Black Ledge River

Marlborough, Connecticut

REPORT

The Blackledge River
 Diversion and Subdivision
 Marlborough, Connecticut

BLACKLEDGE RIVER PROJECT
AT MARLBOROUGH, HARTFORD COUNTY, CONNECTICUT. REV. AUG. 1986

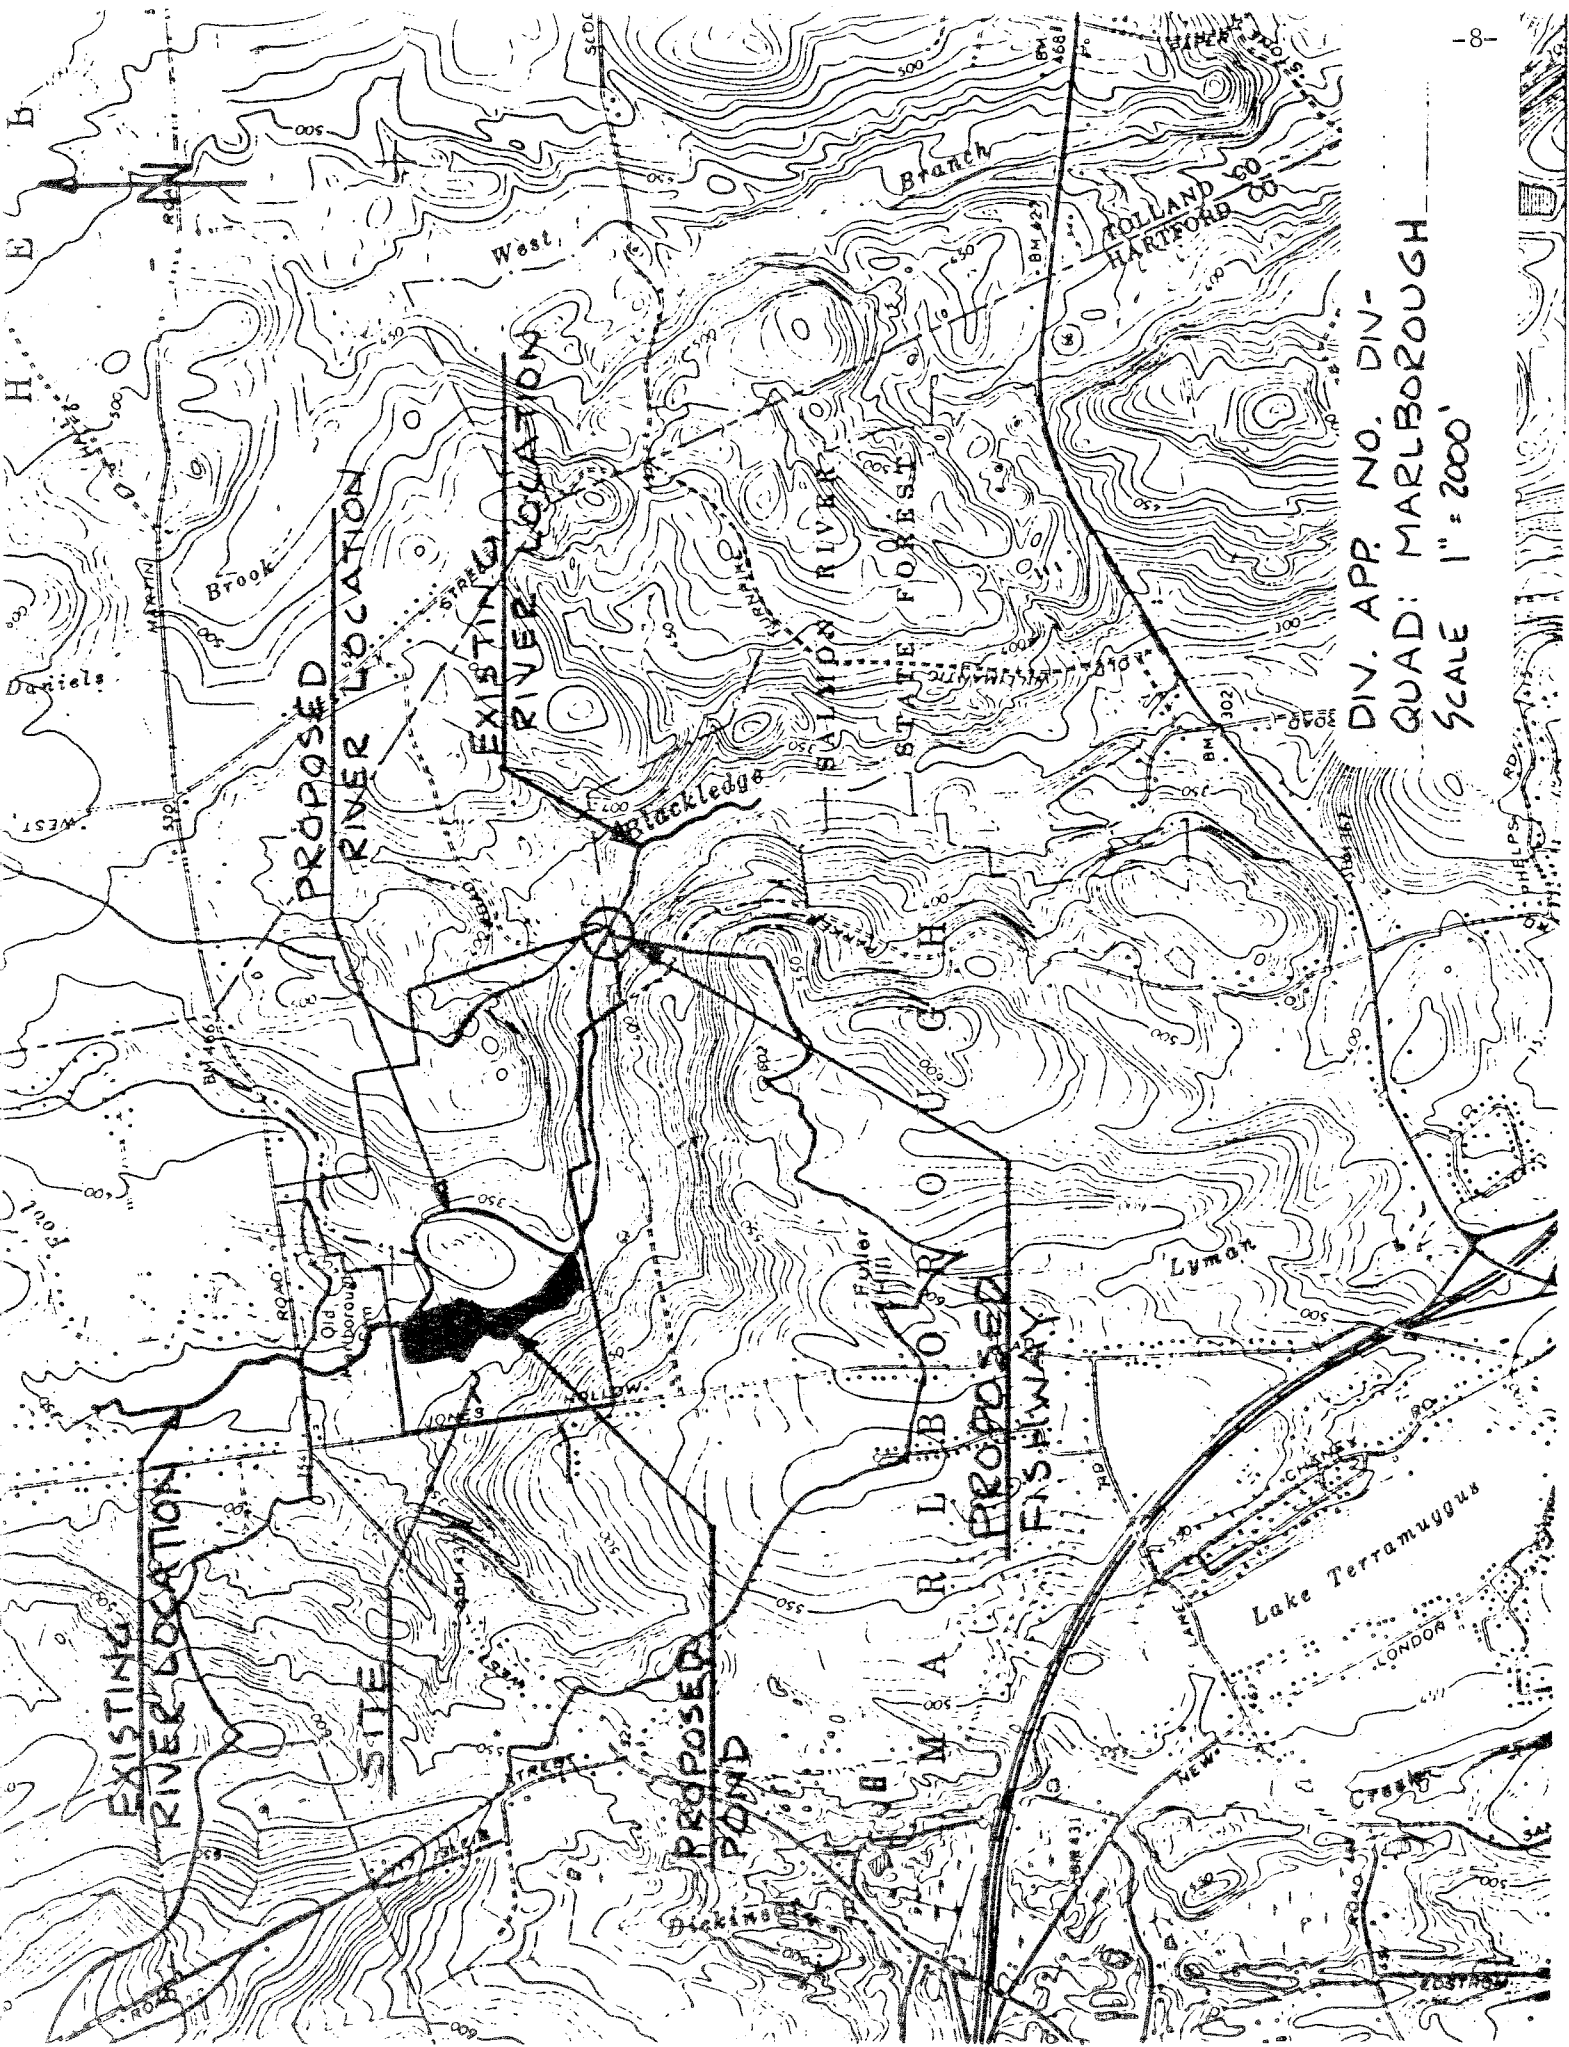
Another major activity which the Town expressed concern about is the proposed +2,900' re-routing of the Blackledge River. Present plans indicate that the river would be diverted around the oval shaped hill in the central parts of the site. The re-routing would allow the river to circumvent the proposed +24 acre pond so that the river would not flow through the pond. It is understood that a through flowing stream into the pond would not be ideal from a fisheries standpoint. Pond water would tend to increase the temperature of the outflowing stream, especially during the hot summer months which may have a negative impact on aquatic life, particularly the salmon population in Blackledge River.

Present plans indicate that the river will be diverted at a 90° angle eastward at the north end of the proposed pond. An overflow berm would be constructed at the north end of the pond to allow inflow during major storm events. Given the large size of the watershed (+14 square miles or +9,000 acres) flows in Blackledge River can be quite significant during major storm events, e.g., 50 and 100 year storm events. As an example, Connecticut Water Resources Bulletin No. 36 (Evaluation and Design of a Streamflow - Data Network For Connecticut, by Lawrence A. Weiss) indicates a flow of 655 cubic feet per second for the 100 year storm event at its intersection with Route 94 north of the site. At this point, the river drains an area of about 6.75 square miles. Given the potential for significant flows, there appears to be a chance that the proposed berms could fail and allow the river to take its former course. Another scenario could find the river flowing through the pond; as mentioned earlier in the report this could have a negative impact on aquatic habitat, particularly salmon, if the problem was not corrected. This brings to question who will be responsible for maintaining the proposed diversion structures and berms once the proposed project is completed. It seems likely that a regular maintenance and inspection program would be required.

In conclusion, it is in the opinion of the Team's Geologist that the proposed river relocation poses too great an environmental risk, especially since the main course of the Blackledge River has really never been greatly disturbed even during the sand and gravel mining operations. Granted the disturbed area must be regraded to make it more aesthetic, it seems this can be accomplished without re-locating the river. Consideration should be given to leaving the river as is, create some smaller ponds, but retain wetlands, and regrade the area to more aesthetic appearance. A conservative buffer should be established between the river and proposed pond(s).

If the proposed diversion is permitted it is recommended that borings or on-site excavation be conducted along the proposed route. This will allow this project engineer to determine a profile of the bedrock surface. There is a possibility that bedrock may be encountered particularly where cuts are deep.

DIAGRAM A DESIGN AS PROPOSED

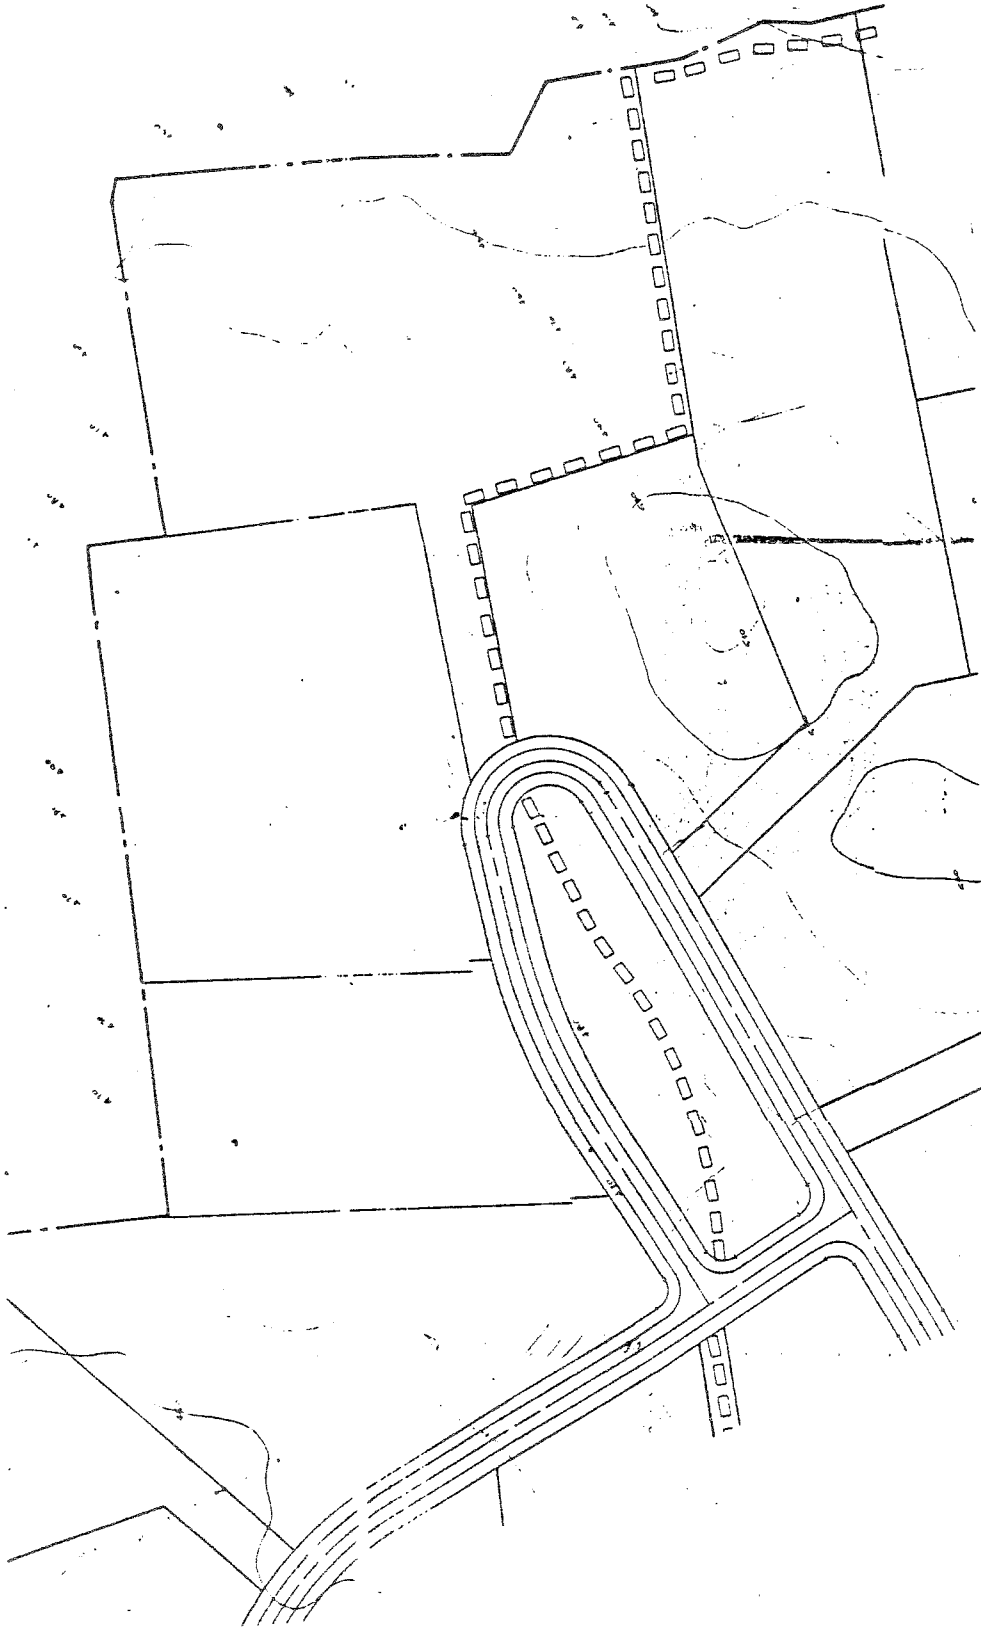
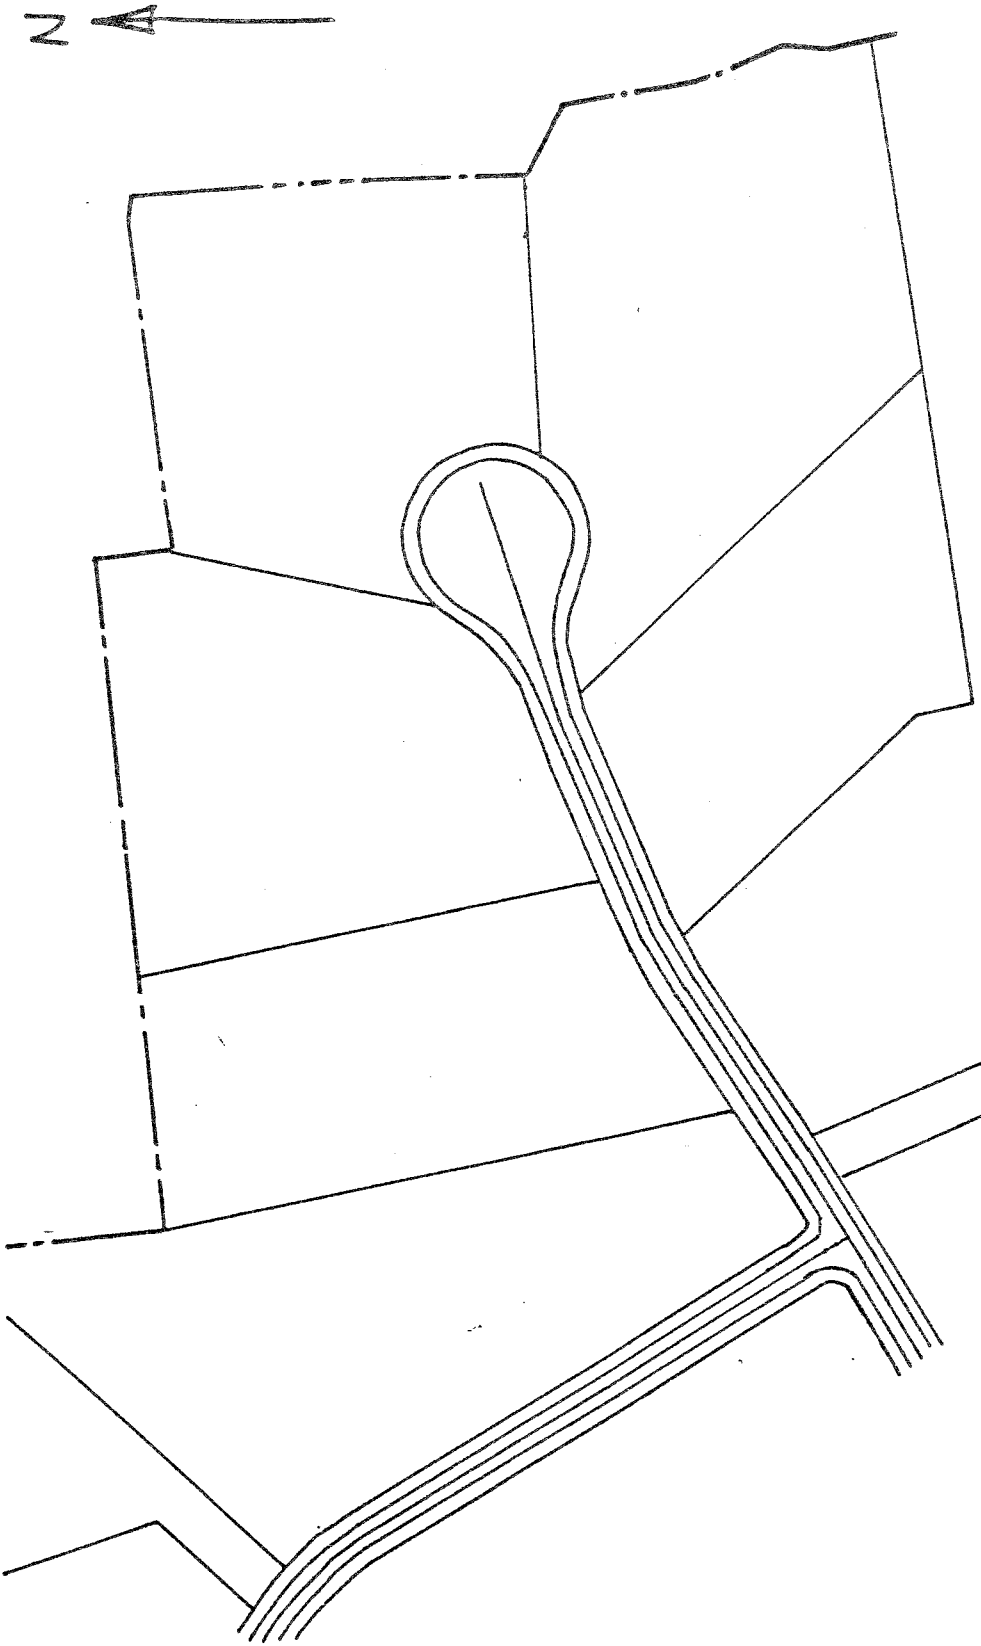
This section will address the design of the proposed subdivision, which is basically sound, but could be improved with some minor modifications. These are primarily two aspects of the subdivision design which will be addressed. One is the fact that no public access had been provided for the very scenic stretch of river located downstream from the proposed diversion. The other issue is the lot and road configuration on the eastern portion of the site.

Sketched out in Diagram B, is the Team Planner's idea of a better lot and street configuration for the northeastern corner of the subdivision.

DIAGRAM B SUGGESTED DESIGN
